Noise Effects from Excavation Under Bund Locations

Figure 1 – Section Through Woodlands, Barrier, and Initial Excavation Site Under the Bund

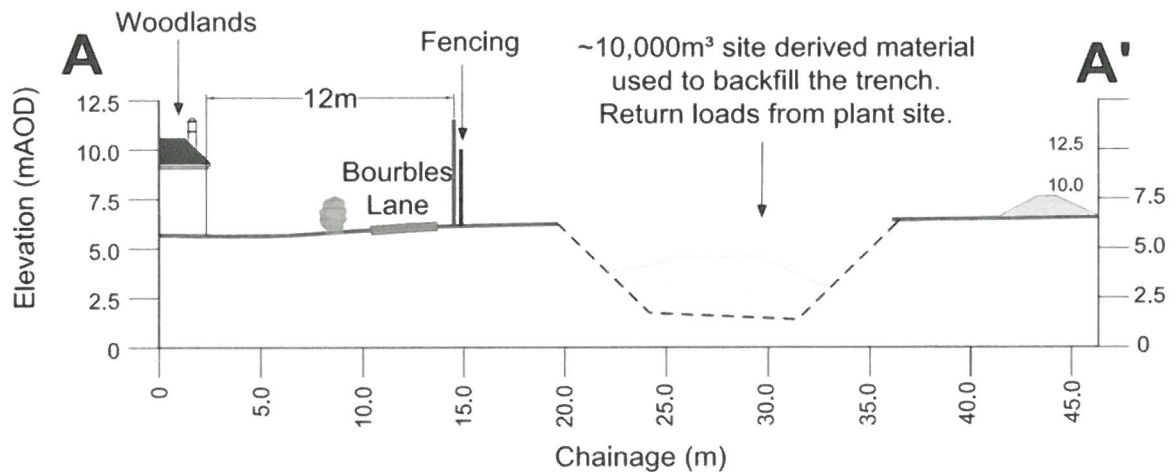
- However, Dr Storey states that noise levels during these excavation works would meet the proposed 50 dB noise limit with the barrier in place. Based on the results of my calculations, I disagree that this can be achieved based on the information currently provided.

- Noise barriers work best where they are high relative to the source and receiver, at least sufficient to block 'line of sight', and located close to the source. Based on the information provided in evidence provided by Mr Simon Rees (16/03/2026) the proposed barrier appears to be approximately 3.75m in height at a distance of 12m from 'Woodlands'. The layout section is shown in Figure 1.

It should be noted that distances noted in the 'chainage' should be reduced by approximately 2.5 to align with the façade of the property.

Figure 2 – Noise Level at Woodlands Compared to Distance from Source, including Barrier

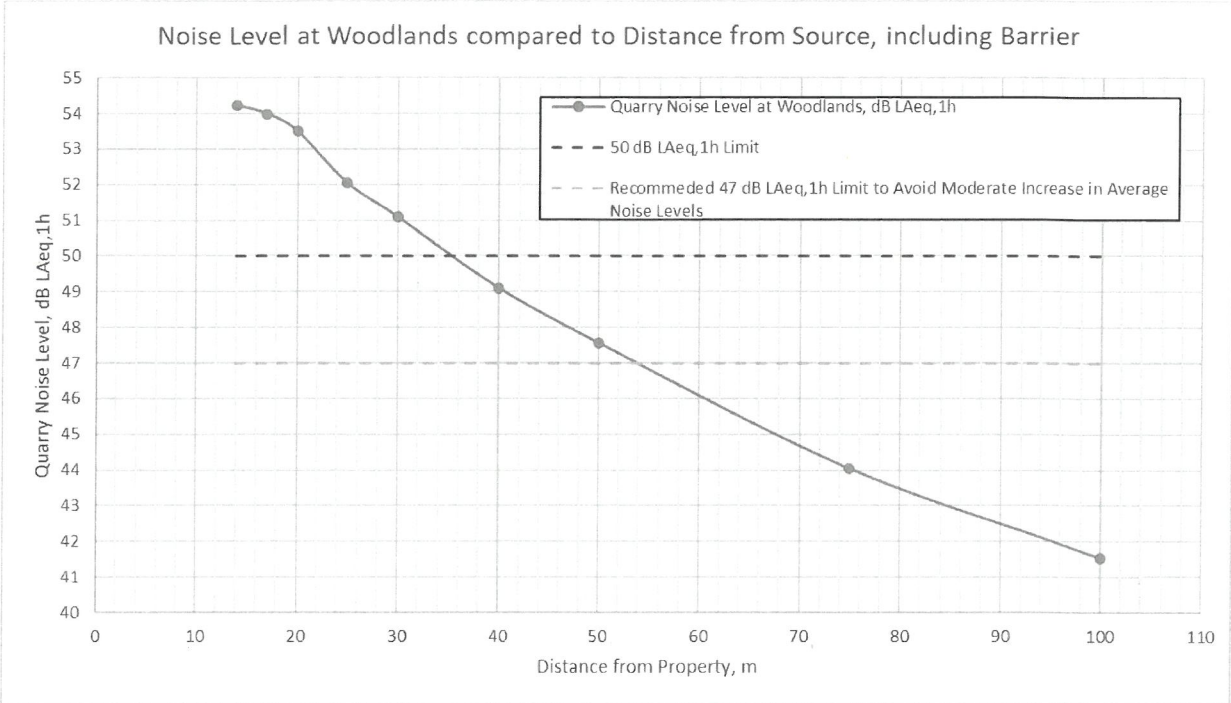
- I have prepared calculations based on the proposed layout and plant data in accordance with the methodology described in BS 5228-1 'Code of practice for noise and vibration control on construction and open sites – Part 1: Noise'. The calculations used the more detailed screening calculation method provided in Figure F.3 of BS 5228, rather than the 'rule of thumb' 10 dB reduction where line of sight is obscured (i.e. a higher level of attenuation is assumed based on the path difference provided by the barrier over various distances). The results are shown in Figure 2t.

- Based on these calculations, my predictions indicate that the 50 dB limit would be exceeded within approximately 35m of Woodlands, with a higher predicted noise level of approximately 54 dB LAeq,1h.
- The initial excavation is between approximately 17.5m and 33.5m from Woodlands (noting the required correction to the chainage). Assuming several meters additional distance for the plant location, this therefore indicates that the 50 dB LAeq,1h limit would be exceeded based on the information provided.
